From: Brant Miller
Sent: Monday, January 23, 2006 4:44 PM
To: 'lloyd@archetypepa.com'
Cc: Al Milasauskis; Bonnie Schucker
Subject: Valley Street Apartments

VALLEY STREET APARTMENTS
GILMAN STREET
PORTLAND, MAINE 04102

DRYER EXHAUST DUCT DETAIL-Ref. Sht. M.3

SECTION AT DUCT CHASE-Ref. Sht. M.3

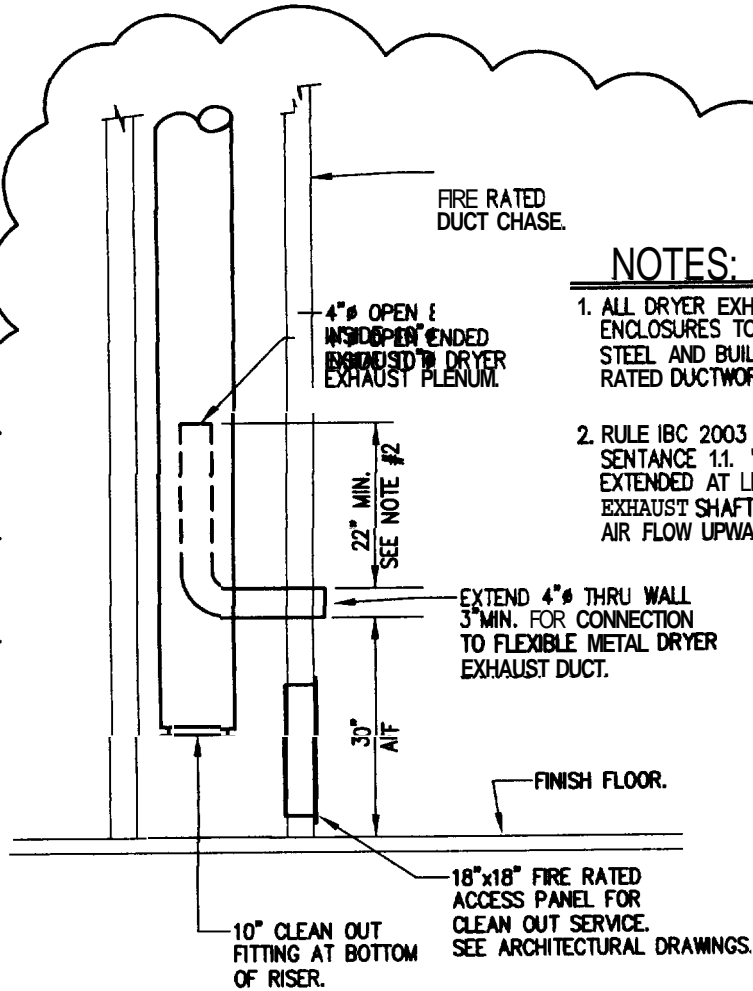
1. ALL DRYER EXHAUST DUCTWORK IN FIRE RATED ENCLOSURES TO BE CONSTRUCTED OF GALVENIZED STEEL AND BUILT TO SMACNA STANDARDS FOR 3' RATED DUCTWORK..
2. RULE IBC 2003 PARAGRAPH 716.5.3.1 EXCEPTIONS #1 SENTANCE 1.1. 'STEEL EXHAUST SUB DUCTS ARE EXTENDED AT LEAST 22 INCHES VERTICALLY IN EXHAUST SHAFTS. PROVIDED THERE IS A CONTINUOUS AIR FLOW UPWARD TO THE OUTSIDE.

NOTE:
THIS DETAIL SIMILAR OF 3RD AND 4TH FLOOR LAUNDRY ROOMS MINUS ACCESS PANEL AND CLEAN OUT.

01-12-06 ADD DETAIL "1" TO SHEET M.3.
RECONFIGURE DRYER EXHAUST DUCTWORK IN CHASE AS SHOWN.

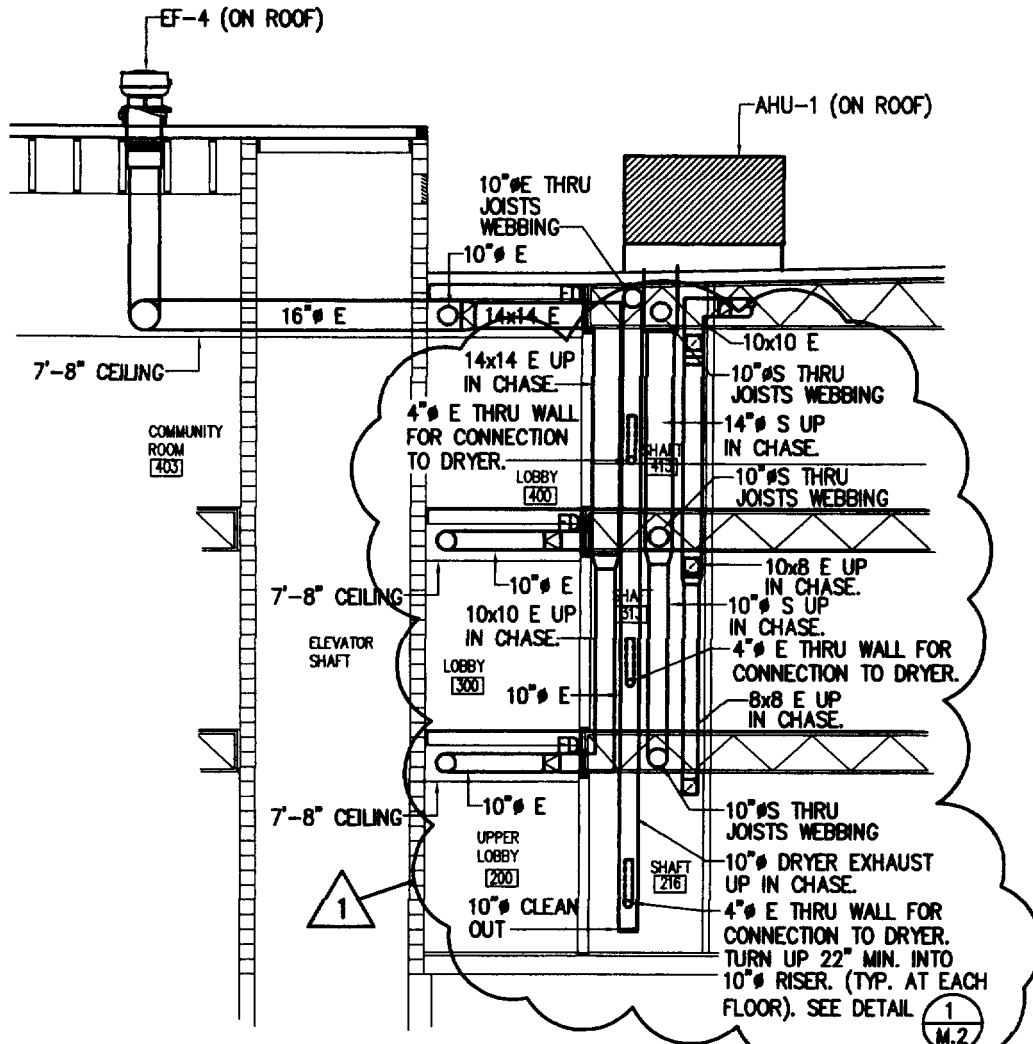
- 1** 01-12-06 RECONFIGURE DRYER EXHAUST DUCTWORK IN CHASE AS SHOW. RELOCATE FIRE DAMPERS TO CHASE WALL(S) WERE INDICATED.
